9.7 Development Permit Application No. 00428 for 2542 Fernwood Road

To: Planning and Land Use Committee **Date:** October 1, 2015

Subject: Development Permit Application No. 000428 for 2542 Fernwood Road

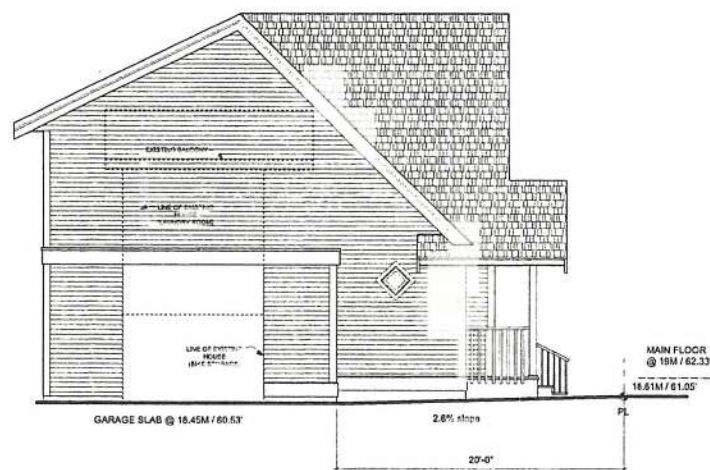
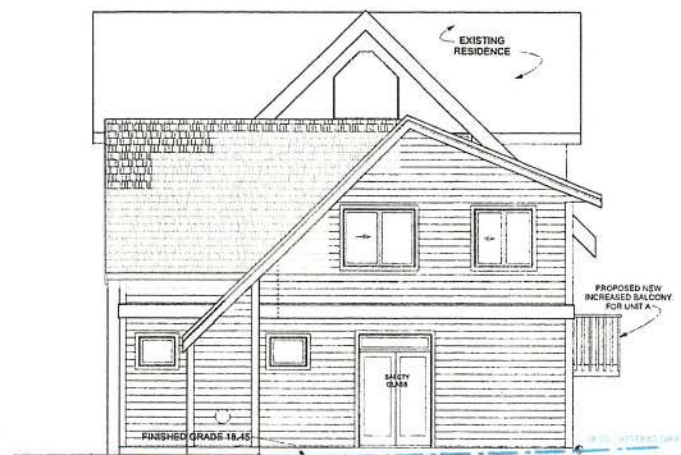
1. Plans date stamped October 1, 2015.
2. Development meeting all *Zoning Regulation Bylaw* requirements.
3. Plan revisions to remove the portion of the upper storey deck on the existing duplex overhanging the proposed garage and resubmit revised elevation drawings to the satisfaction of staff.
4. The Development Permit lapsing two years from the date of this resolution."

There is an upper-storey deck located on the west side of the existing duplex that would overhang the garage. The applicant would like to retain the deck, however, staff have concerns regarding the overall appearance from the street and general cohesion of this aspect of the design with neighbouring buildings. Staff recommend for Council's consideration that the applicant remove the portion of the deck overhanging the garage.
